Subject: Dresden Station Units 2 and 3  
 Additional Response Concerning  
 Fire Protection Modifications  
NRC Docket Nos. 50-237/249

Dresden Station Units 2 and 3  
Response to NRC Staff Requirements  
Concerning Fire Protection

DRESDEN STATION  
FIGURE - 1

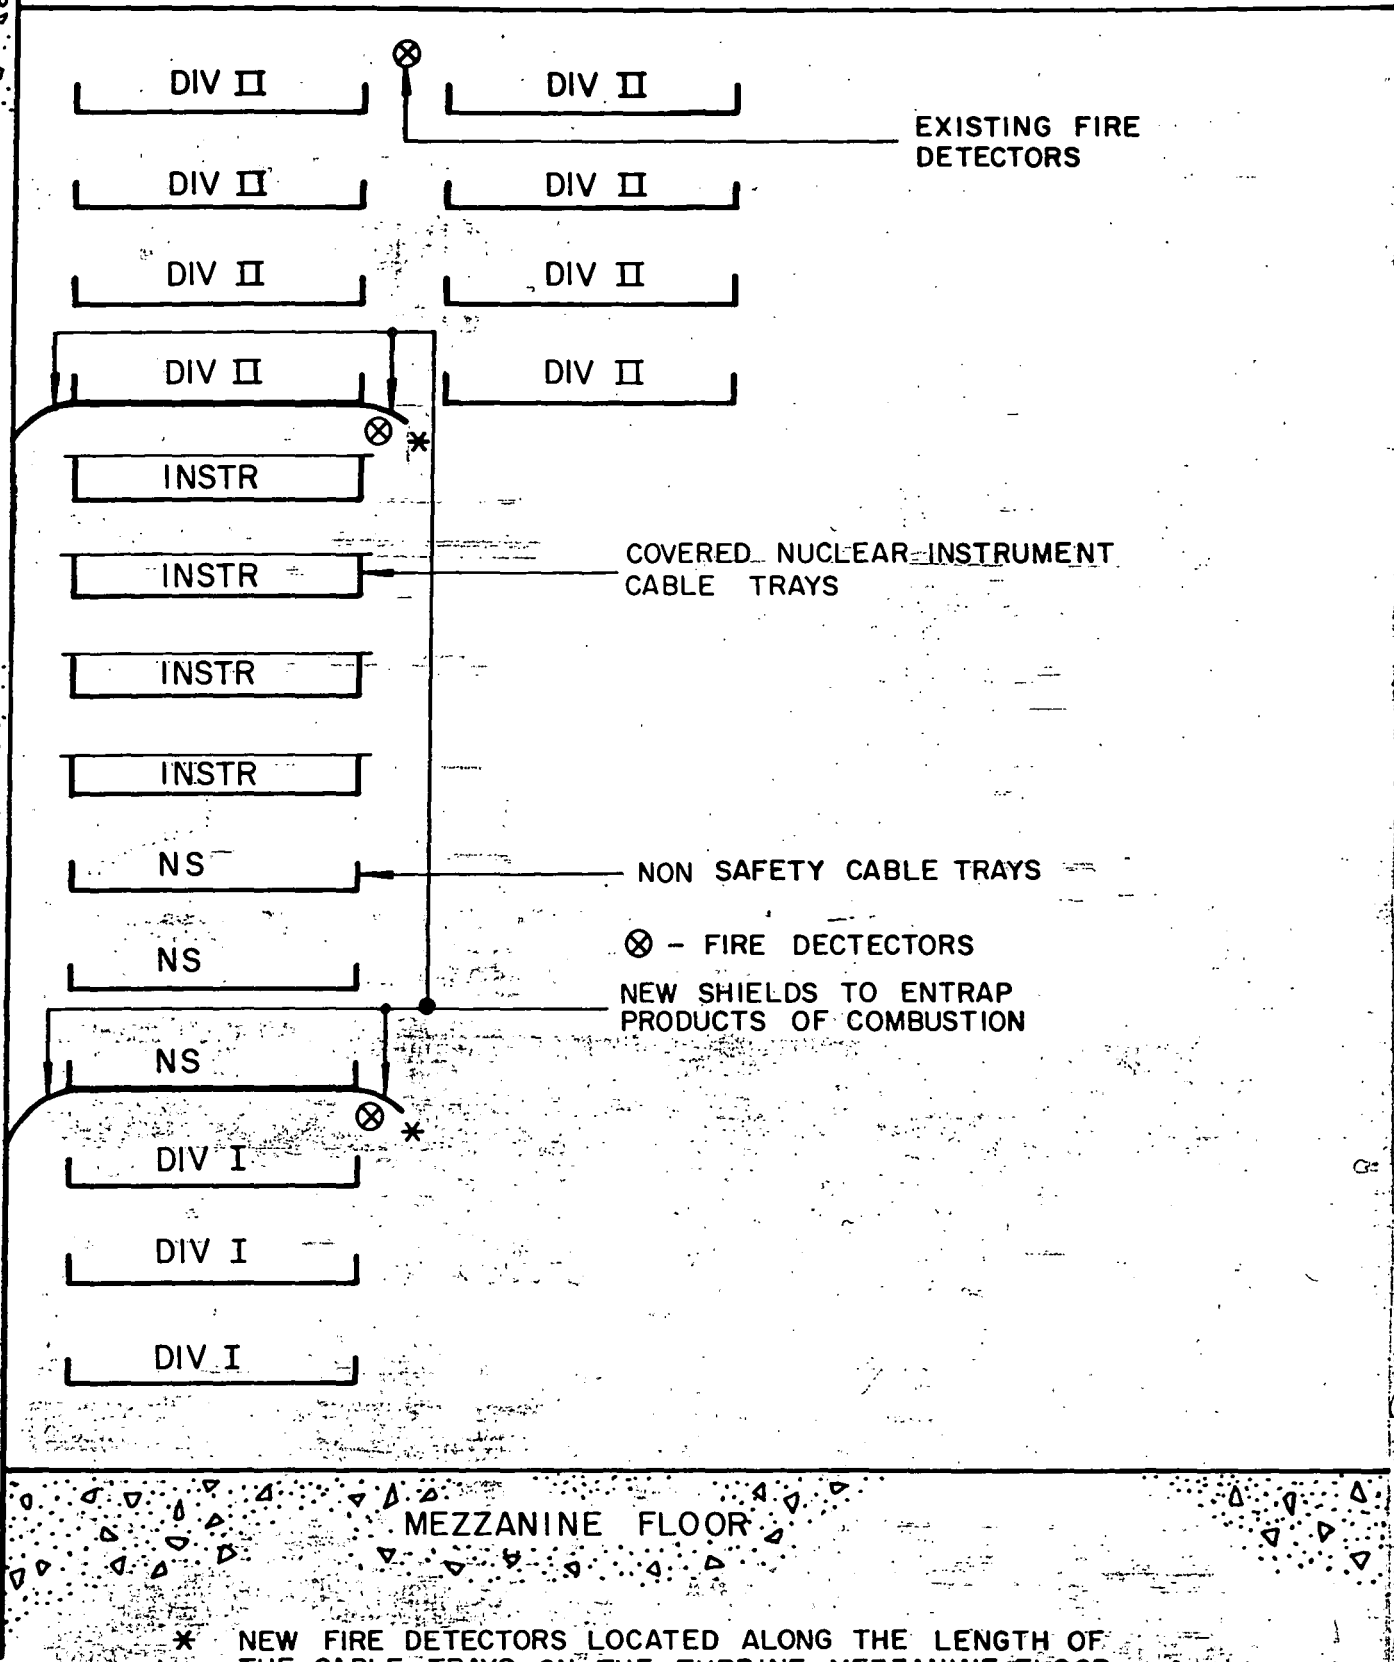
2. Provide line detectors in the cable trays or spot type heat detectors between the horizontal trays for actuation of the pre-action system.

Figure 1 shows the layout of the cable trays along the south wall of the Dresden Unit 2 Turbine Mezzanine Floor. Figure 1 also shows the proposed addition of fire detectors to activate the preaction sprinkler system.

Shields will be placed on the bottom of the 4th tray up from the bottom and on the bottom of the fourth tray down from the top. The shields will extend the length of the trays as they are covered by the sprinkler system.

Fire detectors will be mounted on the under side of the shields at the front of the trays on appropriate centers along the protected length of tray. The shields between the tray and the wall and the shields at the front of the trays will result in a concentration generated in the section of trays below the detectors. The detectors in this configuration will provide early actuation of the preaction system and insure that the system has been charged when the sprinkler system is required.
